TEMPORARY DRAINAGE PROPOSAL (FINAL)

APPLICATION SITE OF PROPOSED TEMPORARY
USE / DEVELOPMENT IN RURAL AREAS FOR A
PERIOD OF 3 YEARS AT LOTS 3250 S.B. SS. 48
AND 3250 S.B. SS. 49 (PART) IN D.D. 104 AND
ADJOINING GOVERNMENT LAND, MAI PO, YUEN
LONG

PROJECT NO. AGLA/TDM/013

Response to Comments on Temporary Drainage Proposal

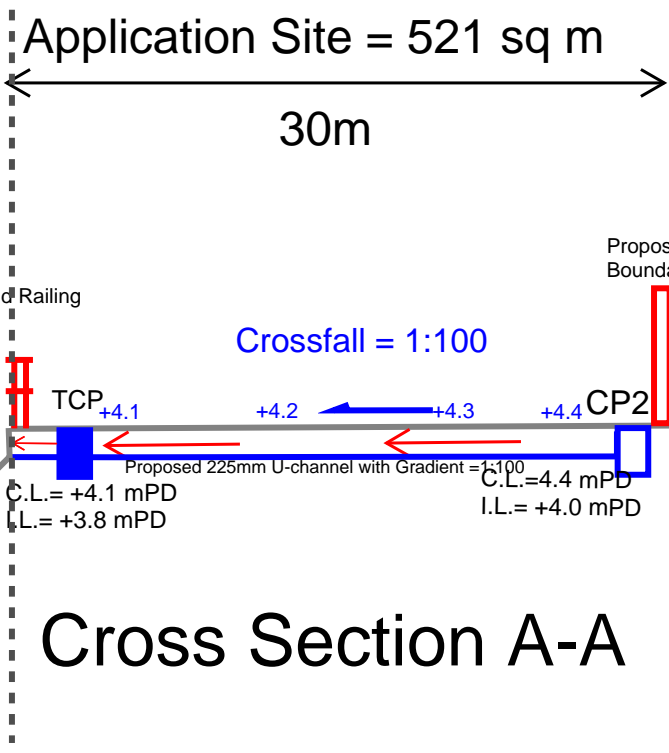
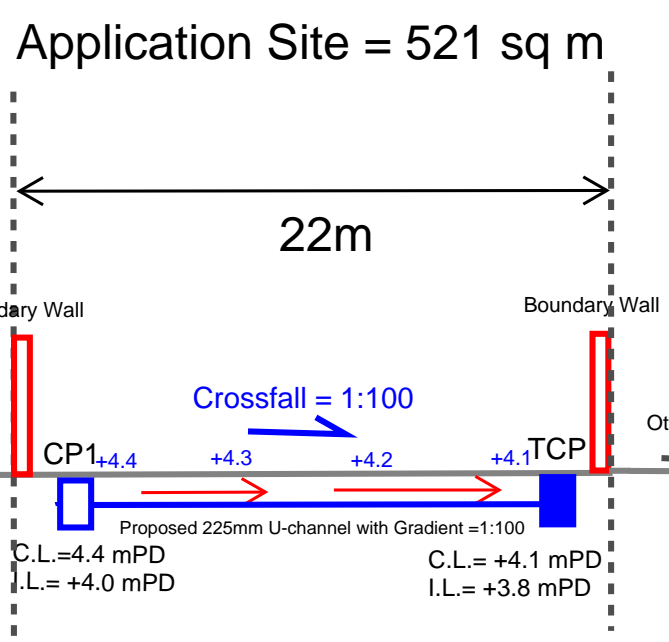
No.	Comments	Response
1.	The levels in cross section A-A and B-B are not correct. All ground levels should be provided. Also, there shall be additional catchment area to be included considering the topography of adjacent site/road, please review the hydraulic calculations accordingly.	<p>Noted and the corresponding spot levels are provided in the sections. Please be clarified that the runoff collected from the adjacent road could be discharge to the existing village gully system.</p> <p>Para 4.2.1: From the Appendix C3 - Site Photos, it emphasized that the topography of the application was generally higher than the adjacent site. Also, the overflow from eastern and southern side of the side were leading to the vehicular road and could be properly discharged to the existing village gully system.</p> <p>Para 4.2.2: However, for conservative, an additional runoff of 100 sq m were considered as external catchment area from the adjacent site. Please refer to the revised Appendix D – hydraulic calculation for your further consideration.</p> <p>Please refer to the appendix C, C1, C2 and C3 of the Proposed Drainage Plan, cross section, viewpoints and Site Photos for your information.</p>

No.	Comments	Response
1.	RtC (k): Please provide another cross section along North-South direction.	Noted and provided. Please refer to the section B-B of the revised Appendix C – Proposed Drainage Plan.
2.	Please advise if any site formation/ land filling works to be carried out under this application. Please note that the overland flow from the adjacent lands should not be affected.	<p>Please be advised that no site formation would be carried out in this application.</p> <p>Please note that the overland flow from the adjacent lands would be collected and discharged to the existing village gully.</p>
3.	Pease advise how the overland flow from the eastern and southern side of the site could be properly intercepted and discharged.	Please note that the overflow from the eastern and southern side of the site could be properly discharge to the existing village gully.

Drawing No. 圖號:
 Appendix C3 - Site Photos

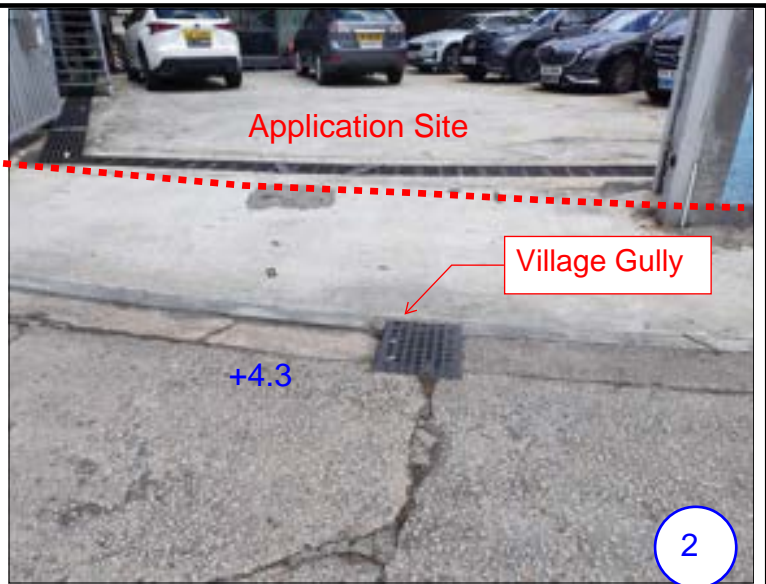
2.	Please provide photo record of the existing village gully for reference, and explain in detail how the overflow from eastern and southern side of the side could be properly discharged.	<p>Please refer to the revised para. 4.2.1.</p> <p>From the Appendix C3 - Site Photos, it emphasized that the topography of the application was generally higher than the adjacent site. Also, the overflow from eastern and southern side of the side were leading to the vehicular road and could be properly discharged to the existing village gully system.</p>
